NSLPP MEETING HELD ON 06/03/24

ADDRESS: 160 Kurraba Road, Kurraba Point

APPLICATION No: DA 191/23

PROPOSAL: Substantial alterations and additions to an existing residential flat building to change the use to a dual occupancy (attached) with alterations to existing car parking and landscaping

Figure 5 – Proposed Landscape Site Plan, Page 3 dated 29 September 2023

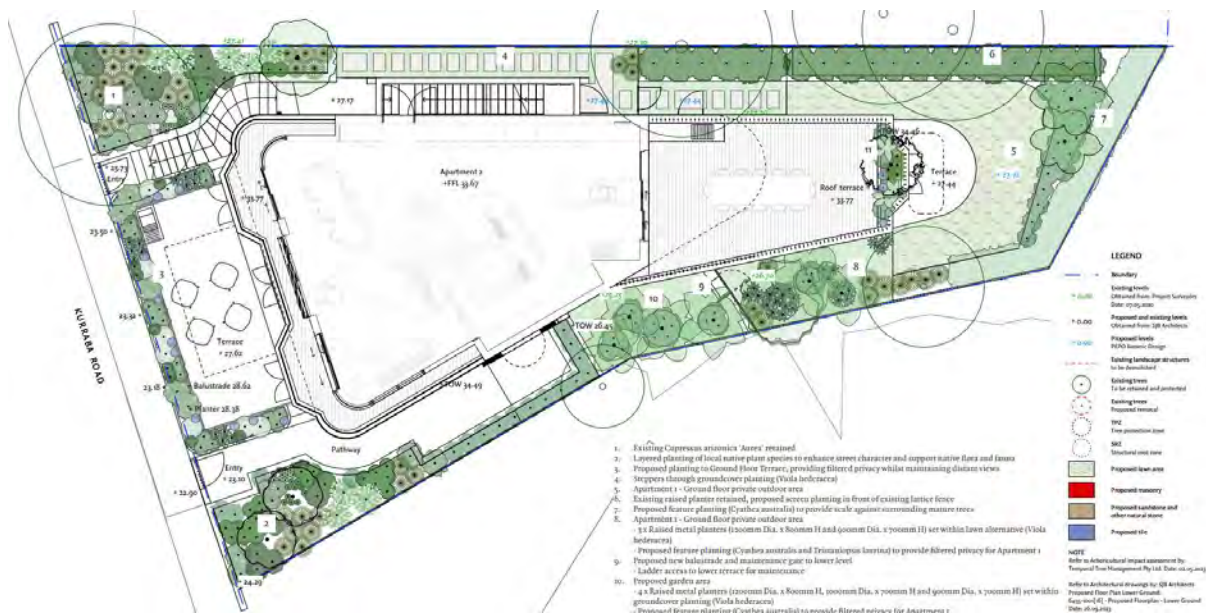
- *The Landscape Plan prepared by Pepo dated 2/5/23 also shows the removal of T1 Cupressus arizonica 'Aurea' (8x4m). The removal of this tree is not required for the proposed works, its retention is recommended in the arborist report therefore removal of this tree is not supported.*

- *There is an existing landscaped area non compliance which will be further reduced. The areas of gravel within the rear setback are not considered landscaped area and shall be replaced with a chequerboard style pattern of paving interplanted with either Ophiopogon japonicus 'Nana', Dichondra repens, Viola hederaceae or similar, with sections of infill to be the same size as the pavers (400x400mm min).*

- *The removal of existing garden and widening to the side pathway along the northern boundary of the subject site and removal of 1 x Olea europaea raise issues of screening and privacy loss, non-replaceable canopy loss, and loss of landscaping to soften built form. 1 x Morus alba (10x4m) is located across the northern boundary of 160 Kurraba Rd & the southern boundary of 158A Kurraba Rd. This tree is shown for retention but some modification would be required to the path to allow for future growth of this tree or alternative screen planting will be required.*

- *The new masonry wall within the rear setback encroaches within the SRZ/TPZ of Tree E04 Jacaranda mimosifolia & Tree E05 Viburnum sp. and shall be relocated in line with or to the south of existing garden edge in this area. No level change shall be permitted to the north of this wall.*

Planning Comment: amended Landscape Plans seek to retain the Cupressus arizonica 'Aurea' within the north western corner of the site. The previously proposed decorative gravel has been removed and replaced with a lawn area. The removal of 1 x Olea europea to accommodate the side pathway would not impact upon privacy noting the existing side boundary fence will remain.

The amended Landscape Plan has relocated the new masonry wall and sensitive construction techniques including hand excavation, flexible location of footings within the TPZ of any protected tree and to ensure that tree roots greater than 40mm will not be impacted or cut as per directions in **Condition D1 Protection of Trees**.

Figure 13 – Annotated Section A detailing various building heights, DA-1501 Rev 19

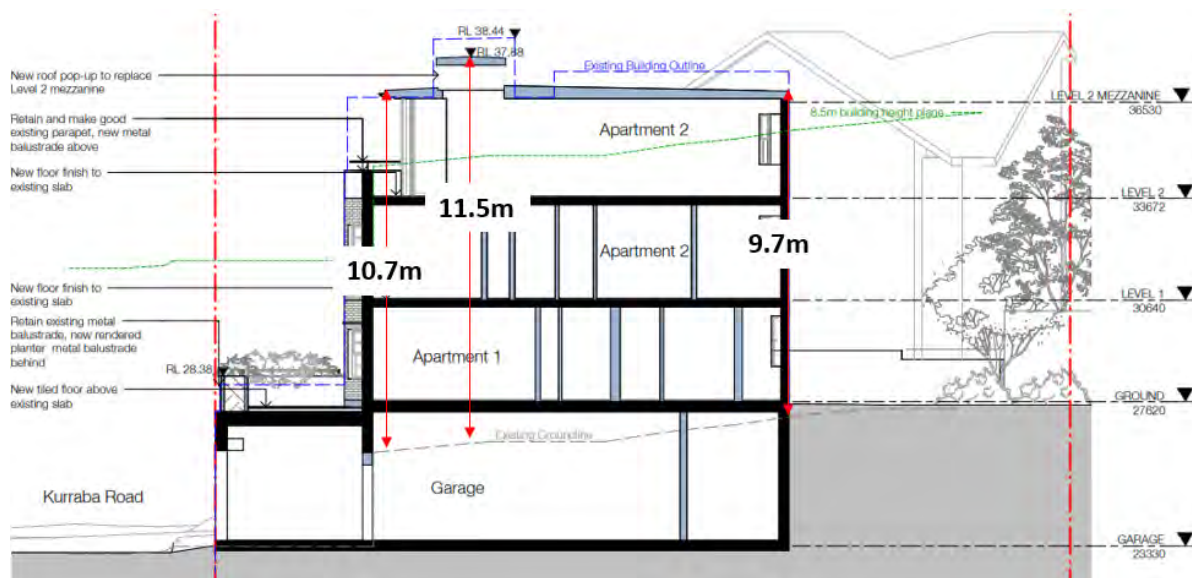
The proposed works would have various height exceedances that fails to comply with the permissible height limit of 8.5m not in accordance with clause 4.3 in NSLEP 2013. The annotated section below highlights the non-compliance with the height limit. In determining the building height noting the existing ground line and existing part excavated garage to the front of the site consideration was given to the Land and Environment Court judgement in *Merman Investments Pty Ltd v Woollahra Municipal Council [2021] NSWLEC 1582*. To determine the building height points measured from the lowest level of the existing building were measured vertically at every point as per the method established in *Merman Investments Pty Ltd v Woollahra Municipal Council [2021]*.

The proposed maximum building height as shown within **Figure 13** is 11.5m in height measured vertically from existing ground level and exceeds the development standard of 8.5m by 3m (35.29%).

Figure 46 – Annotated Level 2 Floor Plan showing siting of the approved privacy screen.

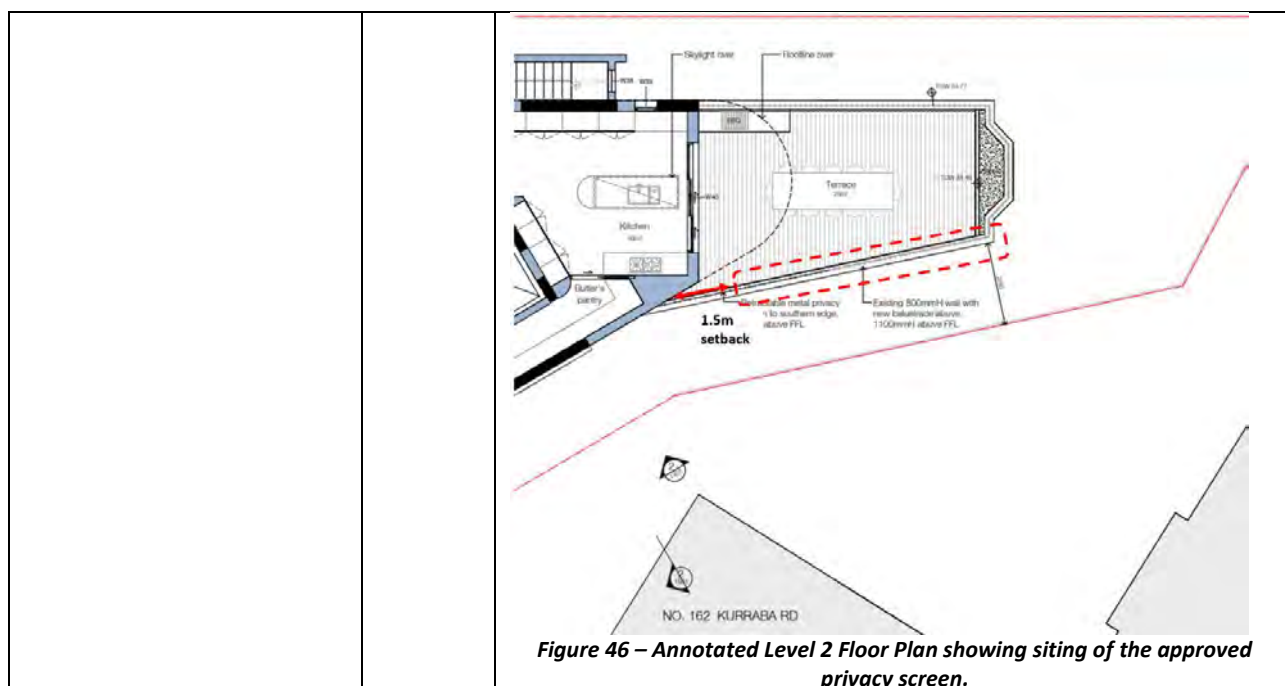
The intent of the above condition is to provide necessary privacy to the most affect balconies of the adjoining 162 Kurraba Road whilst allowing south western views from the rooftop to the Harbour.

Figure 55 – Proposed Site Coverage & Landscaped Area Calculation Diagram, DA-3010 Rev 19

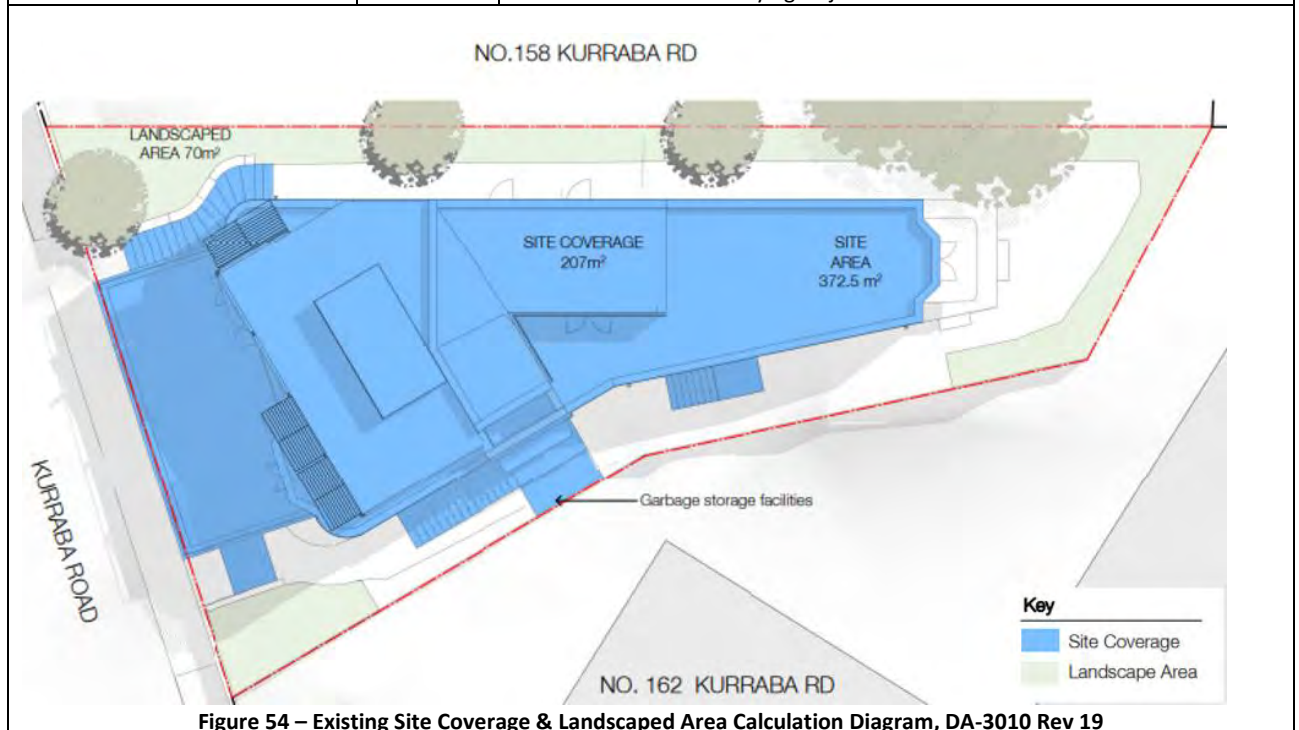
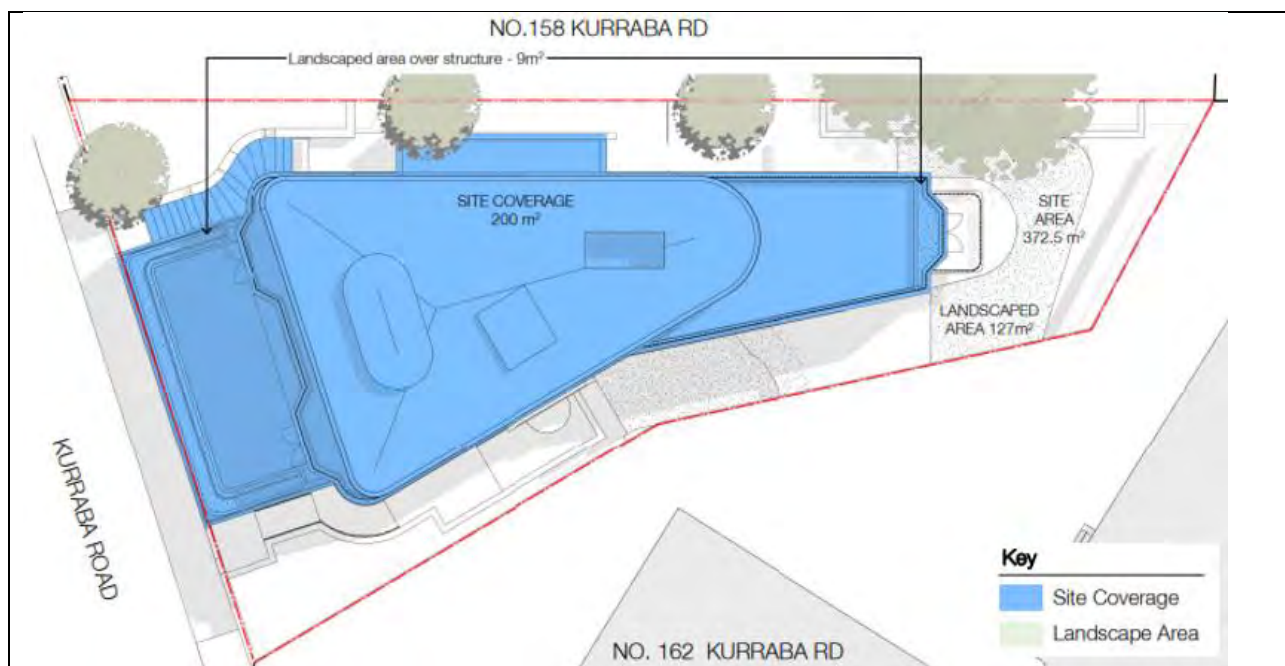
Note: the accuracy of the calculations was checked by Council in comparing the existing and proposed Site Coverage calculations.
